Our Case Number: ABP-314597-22

Re: BusConnects Galway Cross-City Link Scheme.
University Road to Dublin Road, Galway City.

Observation Regarding: Case reference: HA61.314597 University Road to Dublin Road, Galway City

Appendix: Observations on the treatment of cycling in the Bus Connects Galway Cross City Link (University Road to Dublin Road) scheme: Application: HA61.314597

TYPICAL SECTION A-A
 UNIVERSITY ROAD
 LOCATED ON GA SHEET 01
 DRAWING REF: BCG-GA-00-01

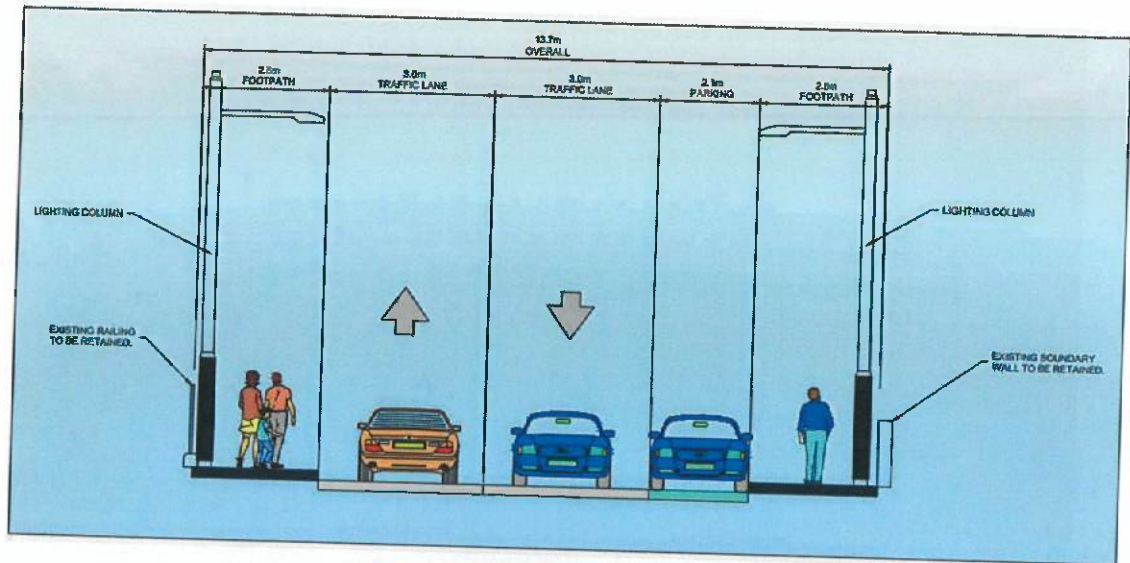
Discussion University Road: If the parking lanes are removed there is scope within the cross section for spacious 2.8m footpaths with wide 4.6m kerb lanes. There is also scope for 2m footpaths, 1.8m cycle facilities and 3m wide general traffic lanes.

There are two sections of on-street parking. The section on the northwest of University road runs along a series of properties that have front gardens - in some cases already converted to driveways. This suggests that other properties at this location could implement driveways and off-road parking, removing the need for on-street parking. On the southeast of University Road there is a section of on-street parking opposite the Millennium Park. If the park is under council ownership then the parking could be relocated to a strip that takes in part of the current park lands.

TYPICAL SECTION C - C
SAINT FRANCIS STREET

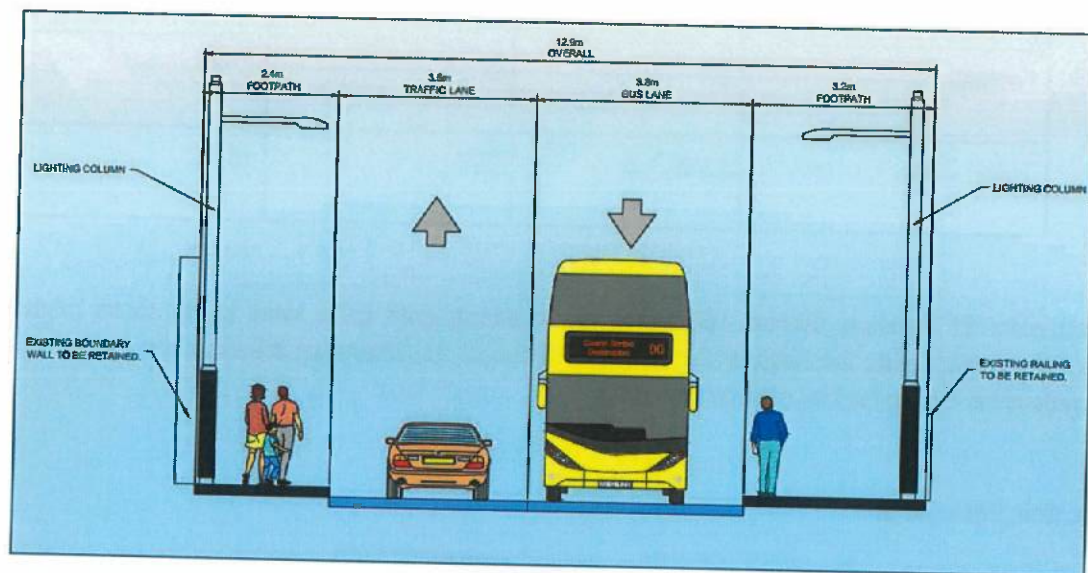
Discussion St: Francis St: The drawings provided in Appendix B2 show that under this scheme Newtownsmith is to be converted to one-way operation going north thus removing it as a means for bicycle users to access

Eglington St. This suggests that Francis St will now be the default way for people on bikes to access Eglington St/Shop St. The dimensions published indicate that there is room for 2m footpaths with wider 4.4m kerb lanes.

TYPICAL SECTION E-E
 EGLINGTON STREET
 LOCATED ON GA SHEET 04
 DRAWING REF: ECG-GA-05-04

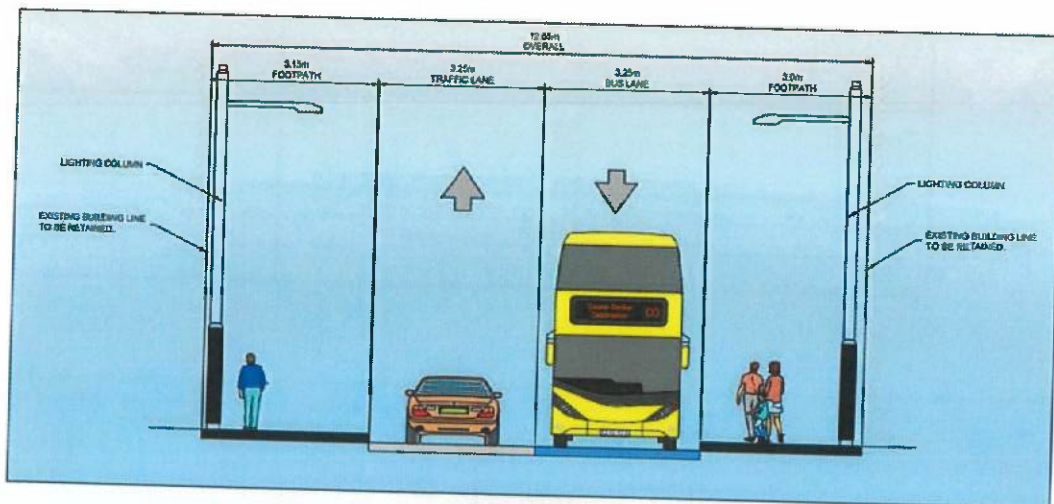
Discussion: Eglington St There is scope within the existing cross section to provide wider kerb lanes of 4.3m and 2m footpaths.

TYPICAL SECTION - F
 BOTHAR BHRÉANDAIN UI EITHIR
 LOCATED ON GA SHEET 03
 DRAWING REF: BCC-GA-00-36

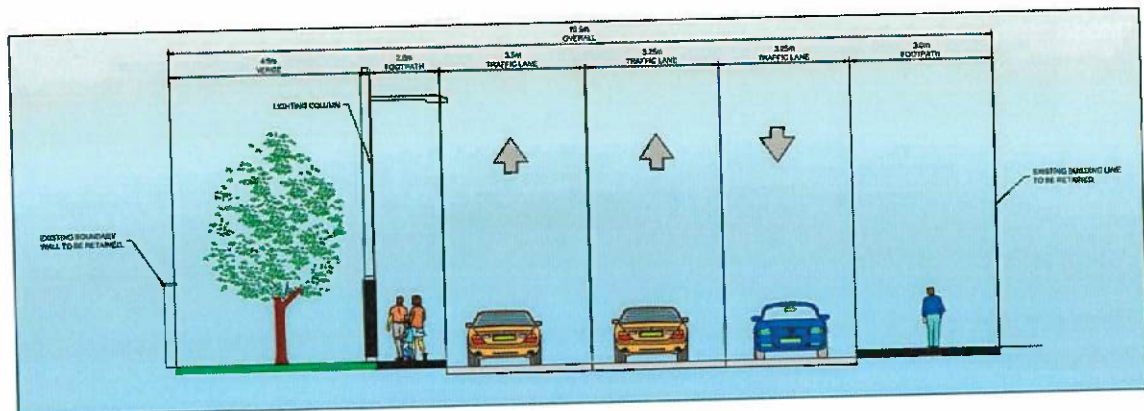
Discussion: Bothar Bhreandain Ui Eithir: By using the 4.5m verge shown in the cross section it is possible to provide 2m cycle facilities on either side of the road.

**TYPICAL SECTION H - H
FORSTER STREET**

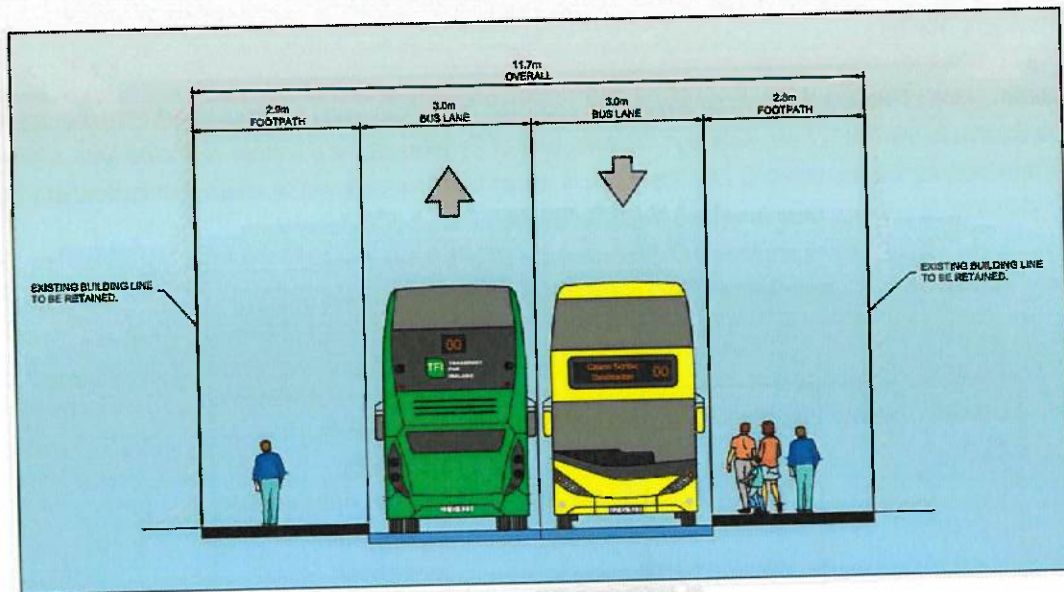
Discussion: Forster St. In the applicant's drawings, Forster street is shown as having bus lanes with no apparent provision for cycling. Alternative 1: By using 2m footpaths it is possible to provide wider bus lanes of 3.8m. 3.8m bus lanes are below the necessary width given by some sources. The problems associated with this lane width might be mitigated by omitting a central lane marking and providing some kind of edge marking (hard shoulder marking etc) Alternative 2: This would involve providing wider footpaths and 2m advisory cycle lanes with a single central traffic lane of 3.7m. In this arrangement motor traffic uses the central lane but oncoming vehicles must merge into the cycle lanes to pass each other. This is a type of treatment (sometimes termed "Edge lane roads") that is established in the Netherlands, Germany and Denmark and has seen some use in the UK.

TYPICAL SECTION J-J
COLLEGE ROAD
LOCATED ON GA SHEET 09
DRAWING REF. BCG-GA-00-09

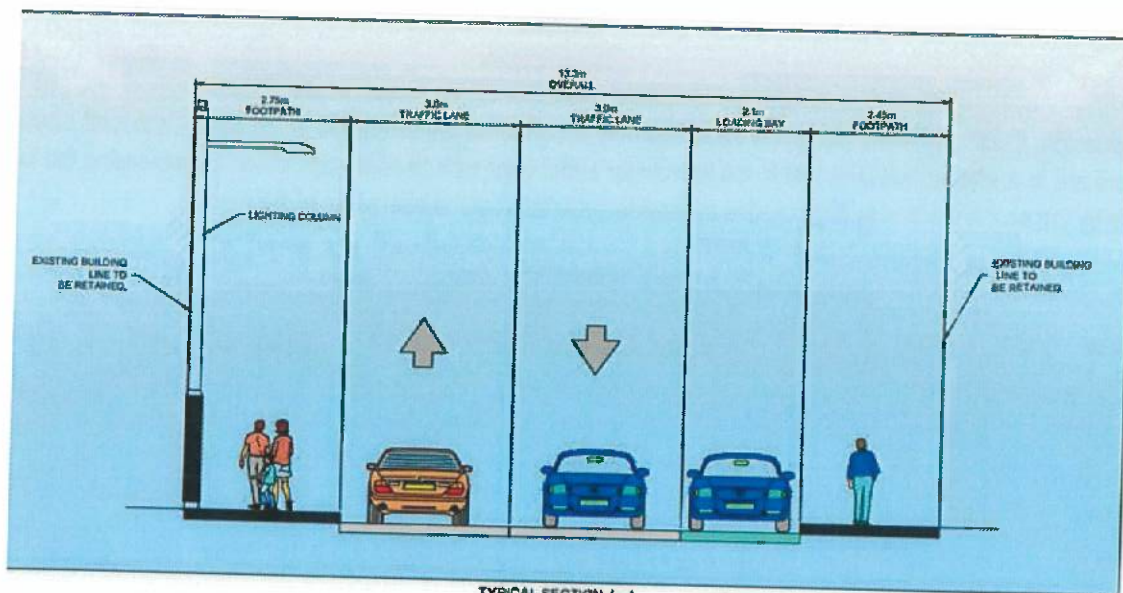
Discussion: College road (Sportsground) The current plans suggest bicycle users sharing with motor traffic in narrow substandard lanes of 3m. Alternative 1: Remove or relocate on street car parking to provide 2m

footpaths and 4.6m wide traffic lanes. Alternative 2: Remove or relocate on-street parking and provide 2m footpaths and cycle lanes of 1.6m and 3m general traffic lanes. Some sources would view 1.6m cycle lanes as being unacceptably narrow and to be avoided, I share that view. However 1.5m cycle lanes are found at other locations in the city. Some of the properties at College road already have ample car parking on site. It is also clear that there are lands north of the road that are already used for parking. Also Galway City Council is in the process of vacating the current site at City Hall for another location. Some of the City Hall lands could be incorporated into the scheme to provide for relocated car parking. There are disabled parking spaces on-street at college road and if there is no suitable alternative location then they could be retained. This would interrupt any cycle lanes so coherent and clear markings would be needed to advise drivers to expect people on bicycles at the obstruction.

Extract from drawing Appendix B2 General Arrangements BCG-GA-02 showing new one-way street restrictions circled in red. The orange arrow shows the imposed direction of travel for people on bicycles who try to use the new bridge.

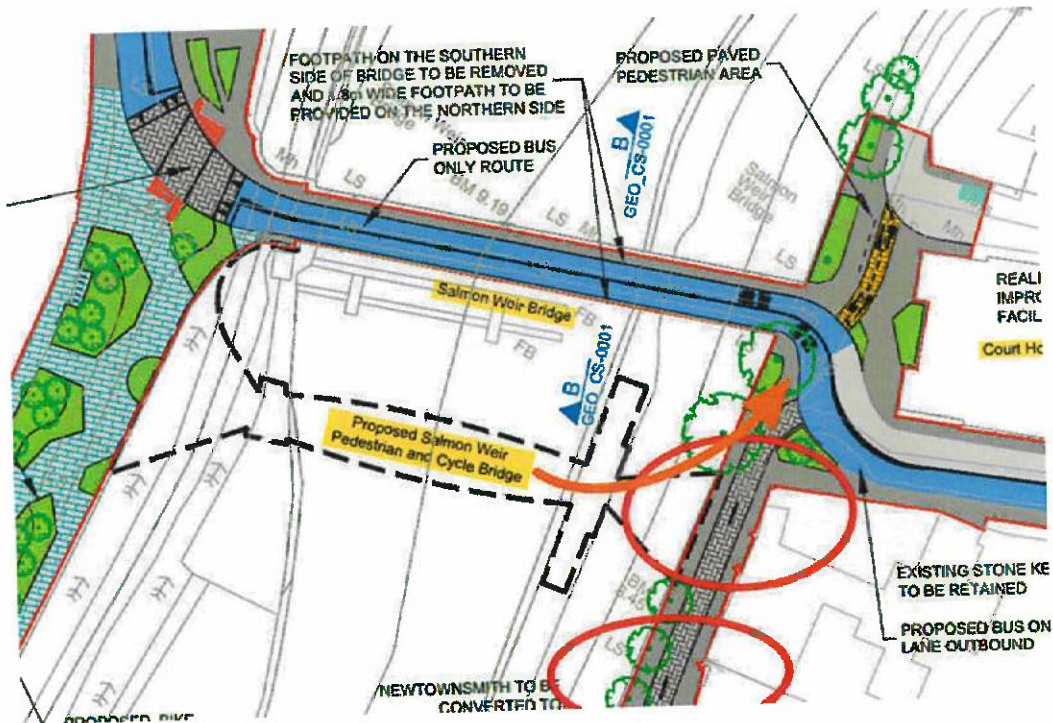
The drawings provided by the applicant show a "Proposed Salmon Weir Pedestrian and Cycle Bridge" linking the cathedral side of the river to Newtownsmith - this bridge is currently under construction. The drawings also show Newtownsmith converted to one-way operation as part of this scheme. The drawings do not show any contraflow arrangements for bicycle traffic at Newtownsmith. The text at Section 3.2.3 *Newtownsmith/St. Francis Street* in the preliminary design report does not discuss the conversion of this street to one-way operation. The text states that cyclists will have access to the bridge "from Newtownsmith" but does not discuss how any bicycle user is supposed to access Newtownsmith from the north or east. The drawings also suggest that any bicycle users crossing on the new bridge from west to east will be required to turn left out onto University Road/St Vincent Avenue to proceed any further. This suggests that, in terms of journey times, the new "cycle" bridge will be of no meaningful benefit to bicycle users coming from the direction of the university or the north-western suburbs of the city. For cyclists coming from the east of the city, there also does not appear to be a meaningful means to access the new "cycle" bridge. This is because Galway City Council operates an extensive system of one-way streets in the city centre, none of which have any contraflow cycling arrangements. All pedestrianised streets are also closed to people on bikes during the period of operation. Because of this system, the only permanently available access point to streets that would bring cyclists to the new bridge is via Bridge St and Lombard/Market Streets on the west side of the mediaeval quarter of the city.

Extract from drawing Appendix B2 General Arrangements BCG-GA-02 showing the apparent path for bicycle users to access the new cycle bridge if coming from the university. It appears intended that bicycle users cycle through the space occupied by people waiting to cross.

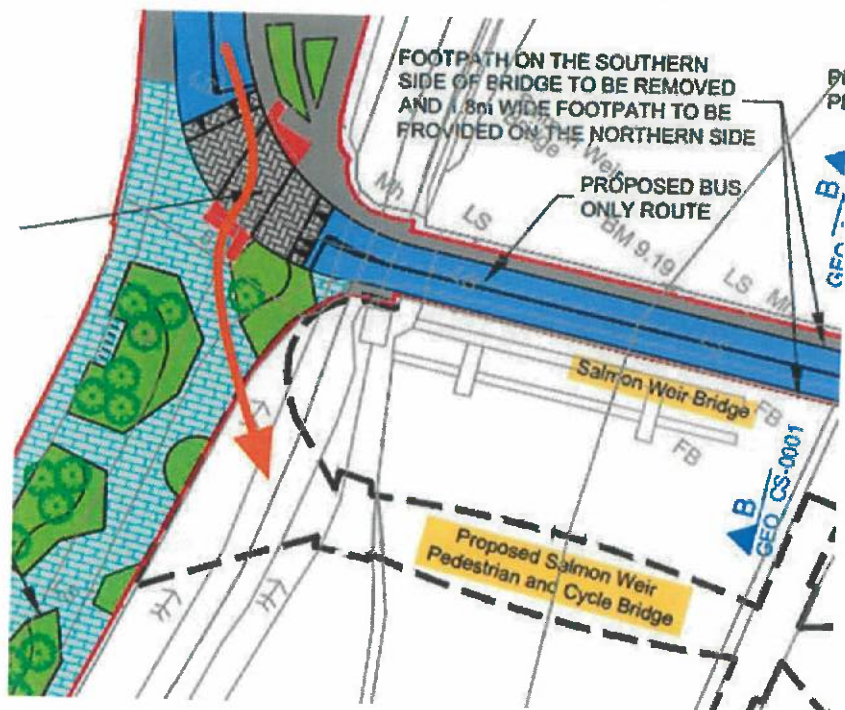
Among various observers of the Bus Connects proposals there is comment about the unsuitable nature of crossing and junction arrangements (see the IrishCycle.com article here for some examples <https://irishcycle.com/2022/09/13/galway-cross-city-bus-link-reduces-traffic-on-some-streets-but-goes-as-far-as-knocking-houses-to-increase-capacity-to-car-parks/>). To give one example the drawings do not show any coherent arrangement so that bicycle users coming from the university might access the new "cycle" bridge. One option is that they must cycle around the cathedral treating it as a kind of anti-clockwise roundabout, this seems counter intuitive. Alternatively they must turn right at the new pedestrian crossing at the western end of the Salmon Weir bridge. This would seem to require people on bicycles to treat the waiting area for pedestrians as a junction for accessing the bridge. A review of all the junction arrangements was outside the time available for preparing this document. The matter might be best dealt with at an oral hearing into the scheme.
